**Zoning By-law Amendment – Aberfoyle South Lake Pit**

**May 26, 2026**

RE: Aberfoyle South Lake Pit – Peer Review  
Part of Lots 18, 19 and 20  
Concession 1  
Township of Puslinch  
County of Wellington

Figure 1

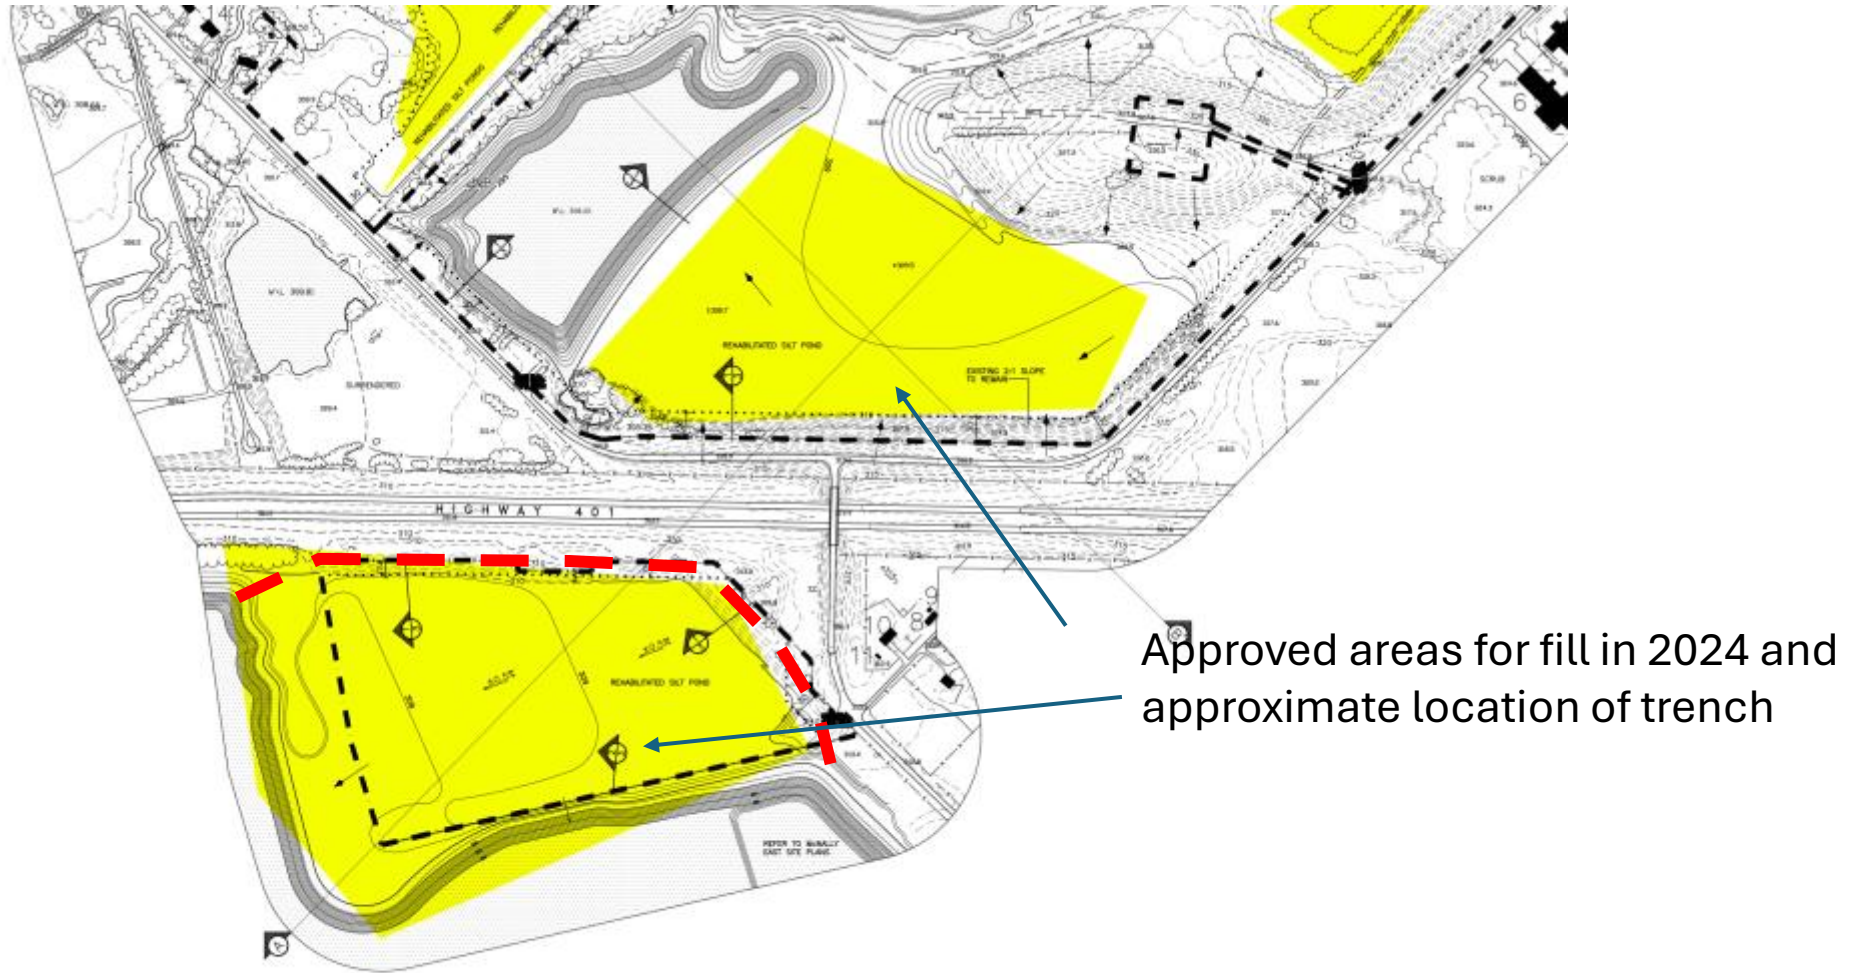
*The proposed pit is surrounded by private property as shown on Figure 1. It is clear throughout the reporting that there will be impacts on both groundwater movement and groundwater elevations beyond the applicant's property lines. For example, all groundwater movement from the CBM property will cease between the proposed lake and Mill Creek along a 1600 m stretch of Mill Creek as shown in the particle tracking exercise. Groundwater levels beneath properties north and south of the CBM owned lands will decrease (east half of site) and groundwater levels beneath properties south and west of the CBM lands will increase (west half of site). There is also the potential for annual seasonal overland flow from the proposed lake onto private lands. The concerns of the private landowners must be addressed. A significant portion of both Mill Creek and Tributary 3 that could be impacted are on private property. To our knowledge no assessment has been made on these private lands.*

Figure 2

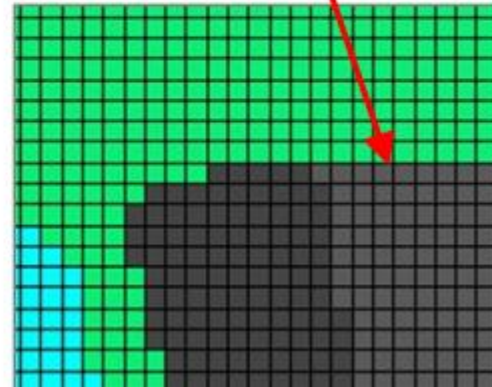
McNally Pond  
Silt Zones

Figure 3

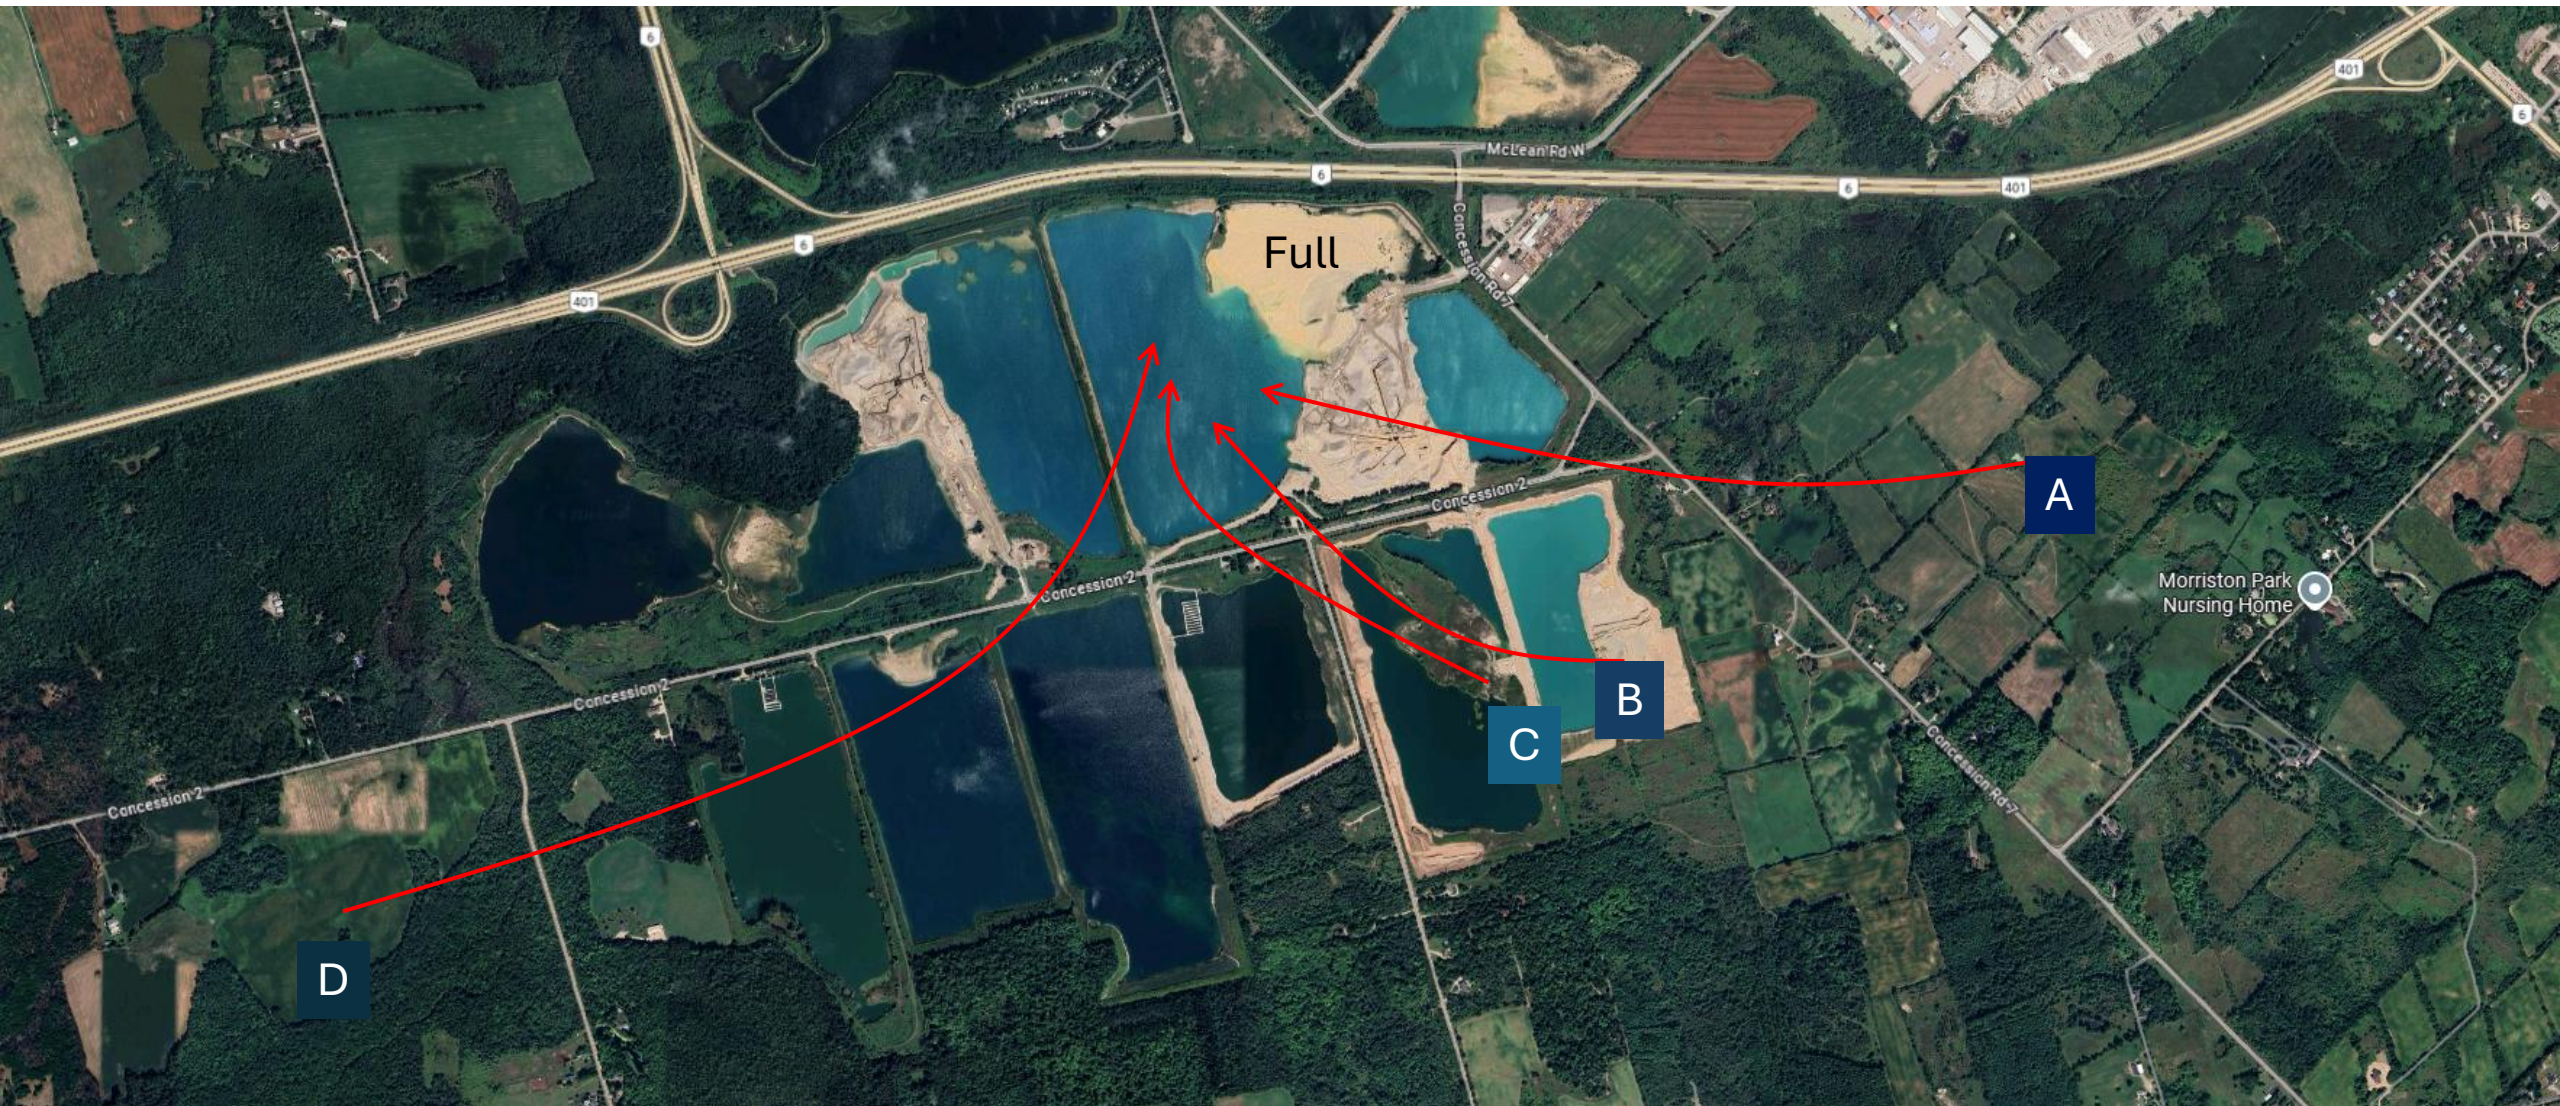
## Potential Effects of Silt Deposition in the McNally Pond on Mill Creek Baseflow

This analysis does not include runoff entering the wetland from adjacent lands. Where no extraction is occurring, this will not change. Where extraction is occurring, any runoff from the extraction area will cease. This may affect zones 2,3,5 and 6 which have lands adjacent to the pit.
